SERVICE BULLETIN

M-1097

NEW REAR CAM ROLLER BEARING ASSEMBLY

Figure 3. Cam Bearings

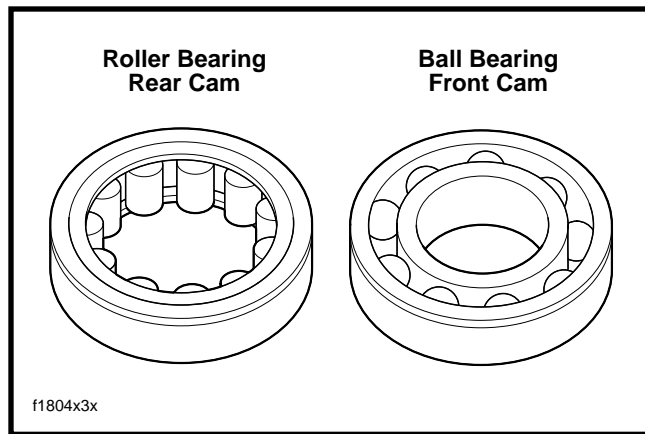
Be aware that the front and rear cam bearings are no longer interchangeable. The rear bearing is now the roller type, while the front remains the ball bearing kind. See Figure 3.

Figure 4. Enlarge Rear Cam Bore Using 7/8 Inch Drill Bit

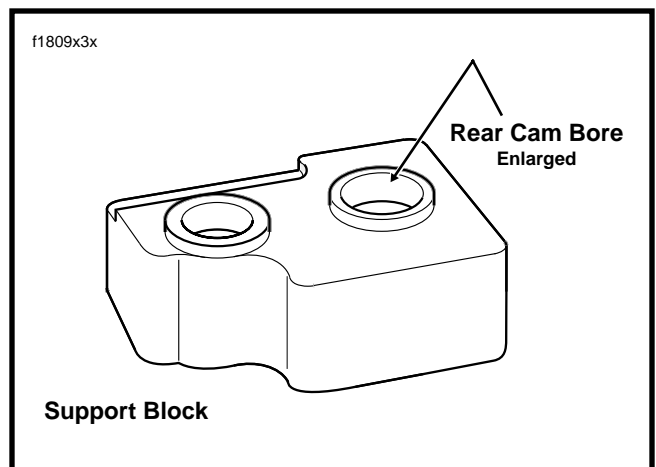
Verify that splined end of rear camshaft has been started into support block. Damage to the camshaft and/or support block can occur if end of camshaft catches top of block during the press procedure.

To reduce the likelihood of such contact occurring, use 7/8 inch drill bit to enlarge rear cam bore in support block. For best results, radius top inside edge of bore after drilling. See Figure 4.

Figure 5. Use New Spacers to Align Crank and Primary Cam Sprocket Faces

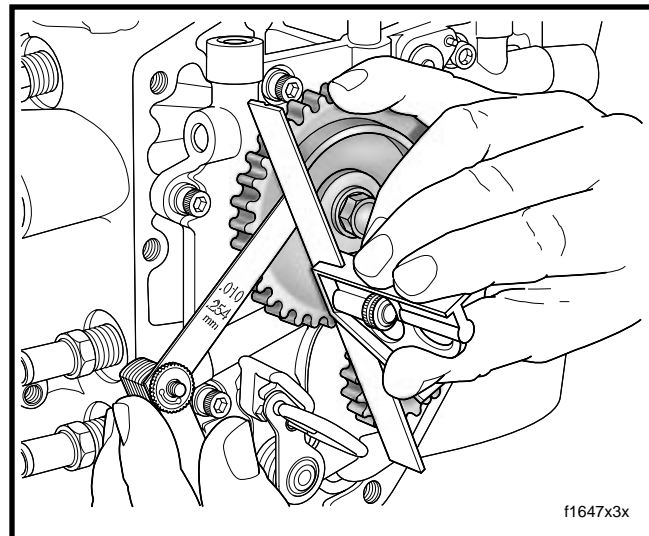
When installing crank and primary cam sprockets, push on rear camshaft to remove end play and check alignment of sprocket faces as described in the 2000 FLT Models Service Manual, and shown in the upper frame of Figure 5. If alignment exceeds 0.010 inch, substitute existing spacer with one of those shown in Table 1. These spacers represent a new set and are to be used with the new rear cam roller bearing assembly only. Do not attempt to use earlier design spacers as they will not work.
